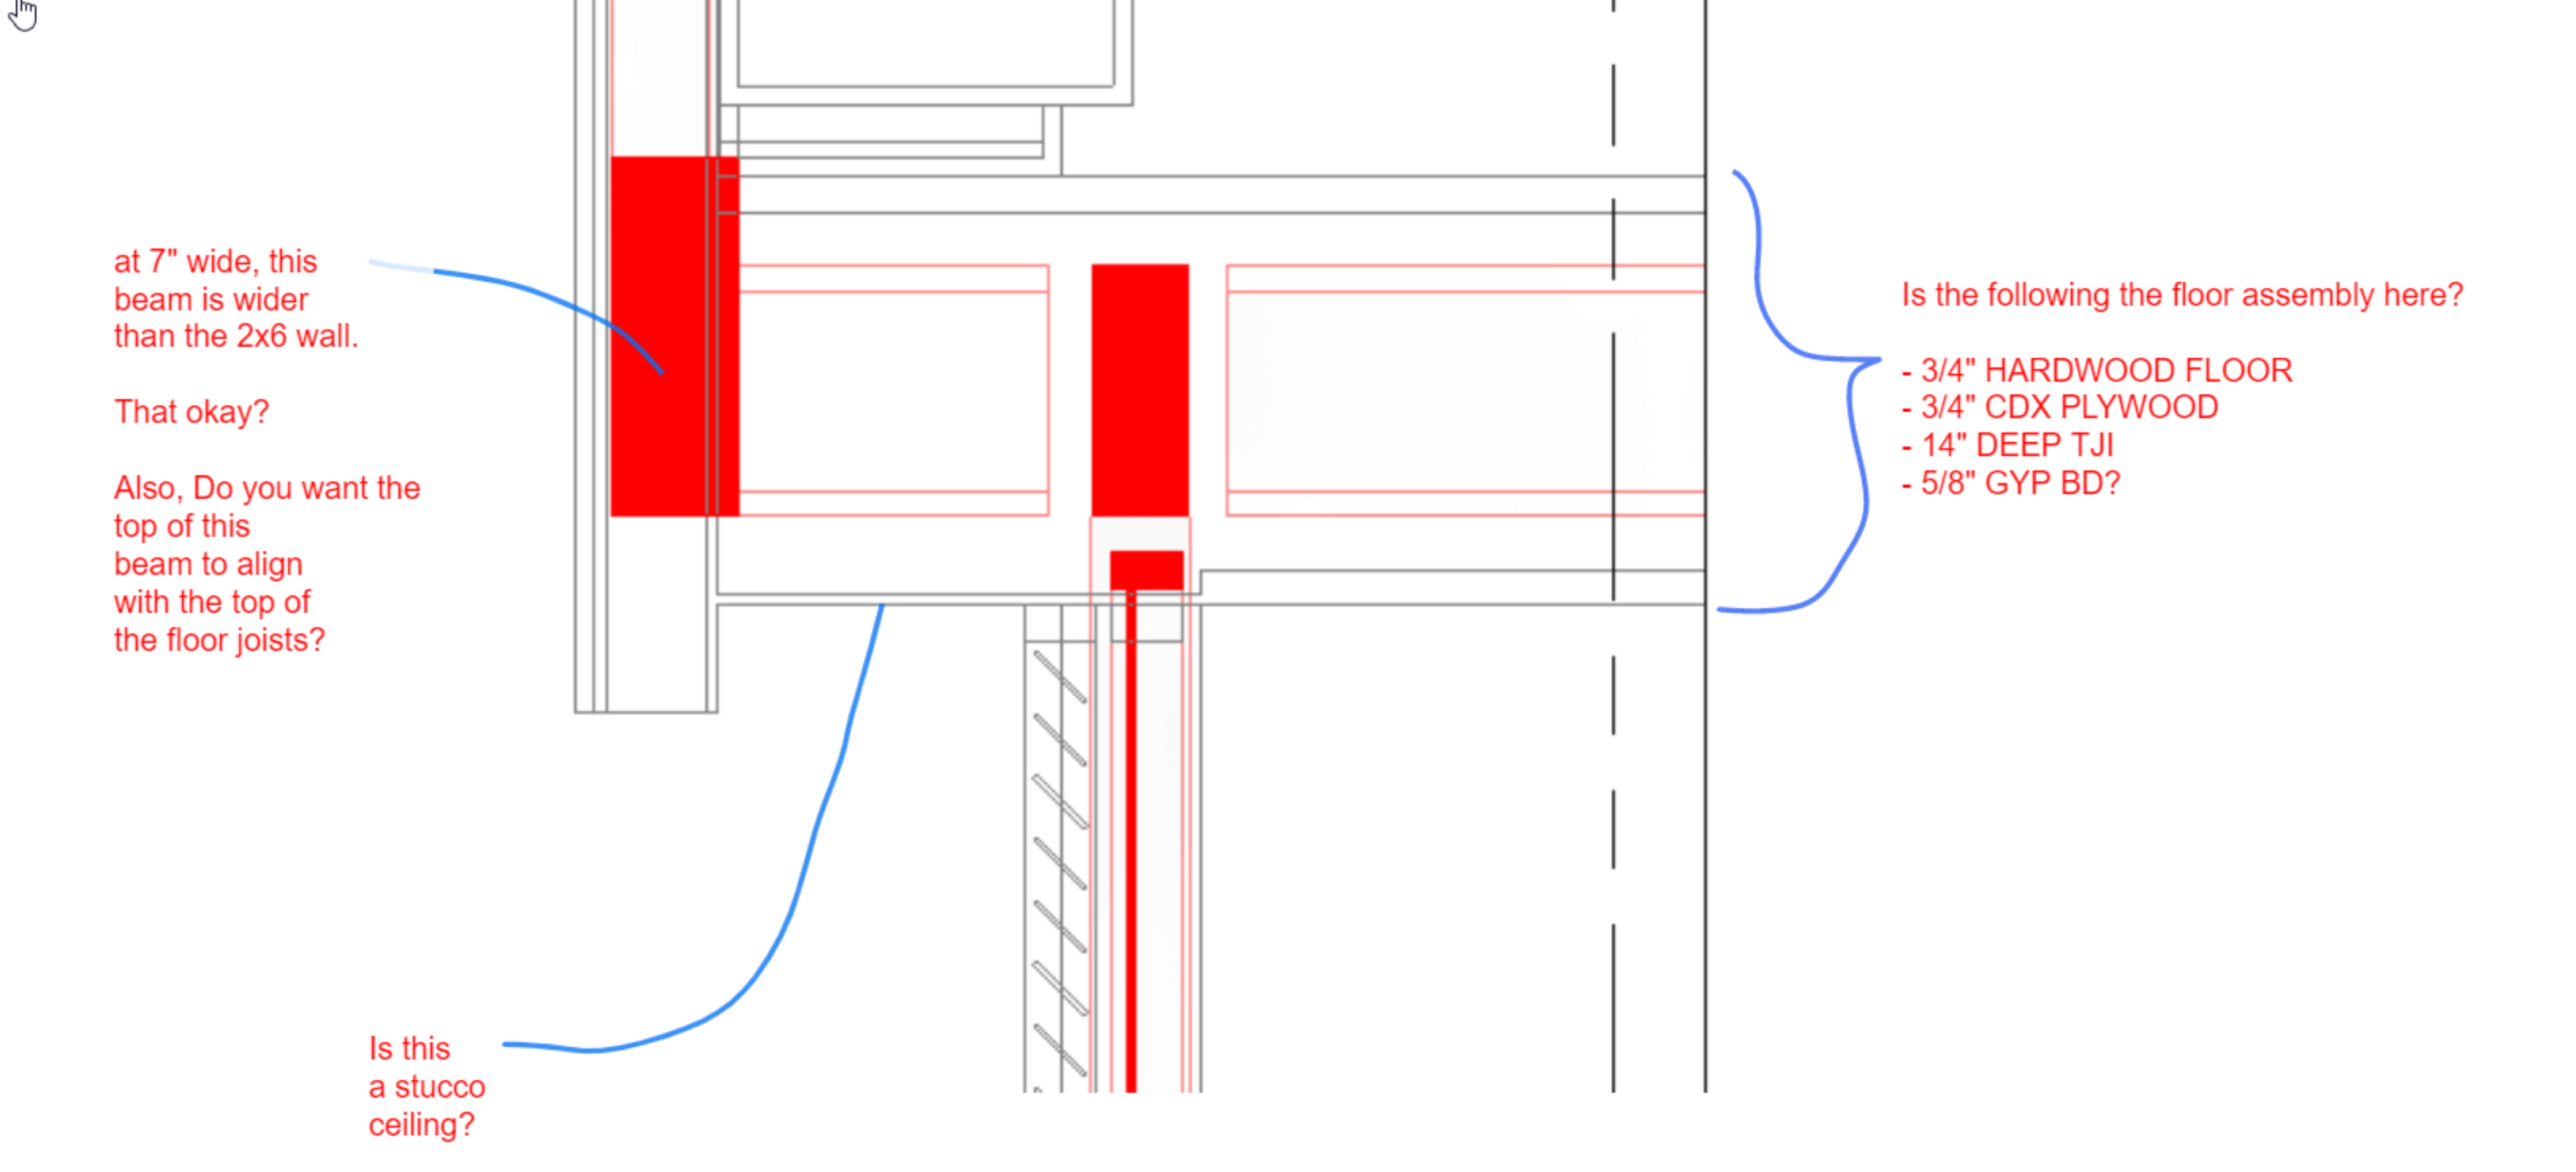
I noticed this type of detail at the eaves.
Does this happen at all the eaves?
Is it a C channel? or Brake Metal?
Galv? Painted?

at 7" wide, this
beam is wider
than the 2x6 wall.

That okay?

Also, Do you want the
top of this
beam to align
with the top of
the floor joists?

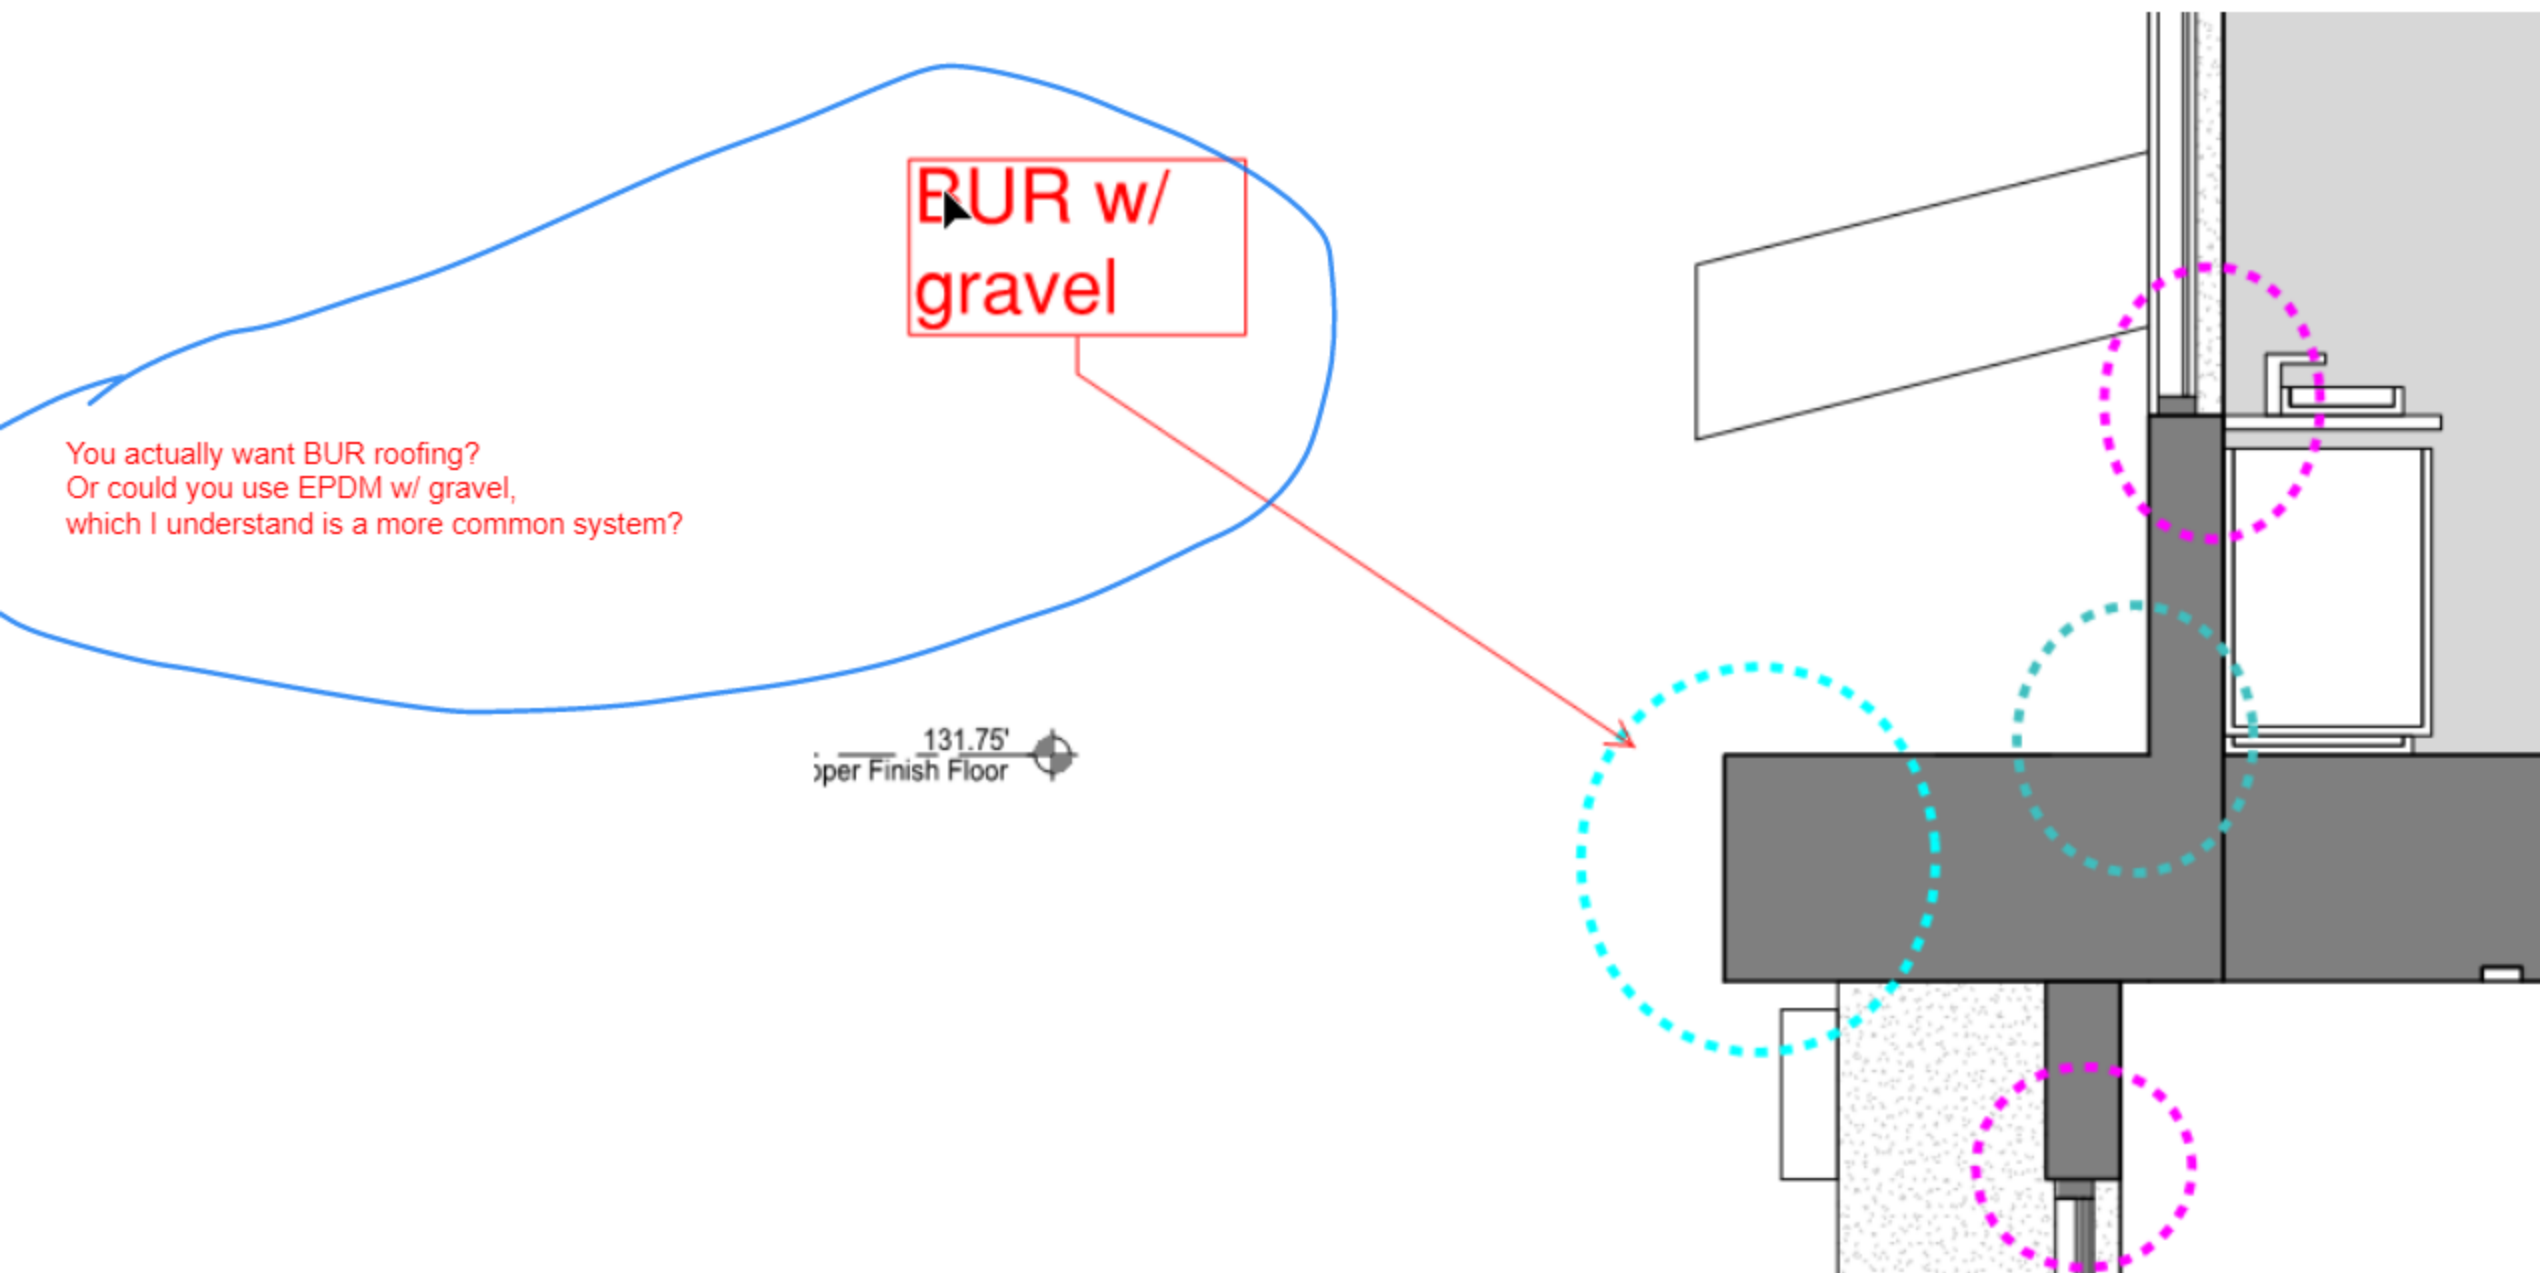
Is this
a stucco
ceiling?

Is the following the floor assembly here?

- 3/4" HARDWOOD FLOOR
- 3/4" CDX PLYWOOD
- 14" DEEP TJI
- 5/8" GYP BD?

You actually want BUR roofing?
Or could you use EPDM w/ gravel,
which I understand is a more common system?
